Contract No. 1002EM19A
Design-Build-Operate Contract for the Additional District Cooling System (DCS)
at the Kai Tak Development (KTD)

Presentation to Harbourfront Commission on Updated Additional District Cooling System (ADCS)

Comment 1 : To Reduce Bulky Building Mass

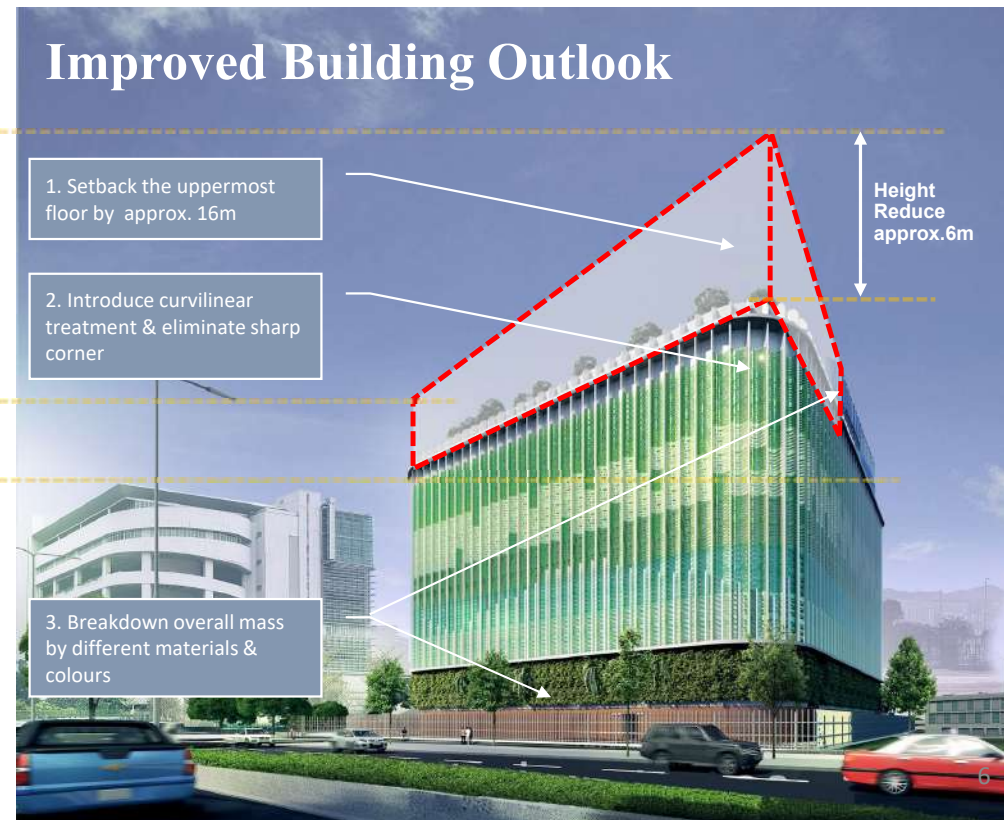
Comment 1: To Improve architectural design- reduce **Bulky Building Mass**

1. Reduce the height & bulk significantly by setback the uppermost floor from the main road (by approx. 16m) & introduce Roof garden facing the main road.
2. Introduce curvilinear façade design elements & eliminate sharp corners.
3. Breakdown overall mass by introducing different façade materials & colour tones at both G/F (vertical green) & 3/F (glass wall & glass cladding).

Site Layout Plan

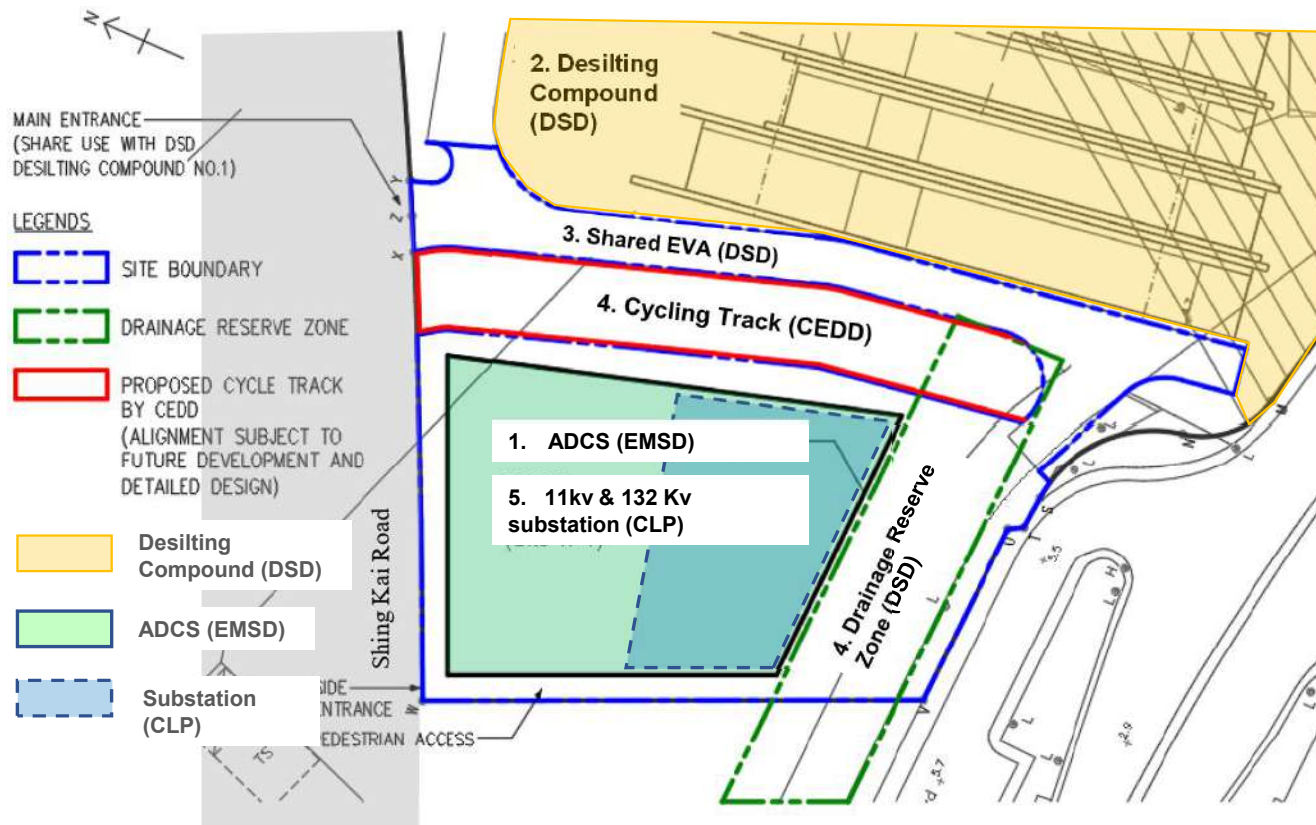
Comment 3: To make the best use of precious land- **Single land with Multiple use**

Comment 3 : Single Land with Multiple Use

- ADCS occupies only a small portion of land and shared with other government departments/ Utilities Company.
- Site Area: Only Approx. 5,056m²
- Shared with :-
 1. EMSD- Additional DCS
 2. DSD – Desilting Compound
 3. DSD – Drainage Reserve & EVA
 4. CEDD – Cycling Track
 5. CLP – 11kv & 132 kv substations & delivery route

Merit : Concept of sharing land has saved approx. 800 m² footprint area and make the best use of limited site area.
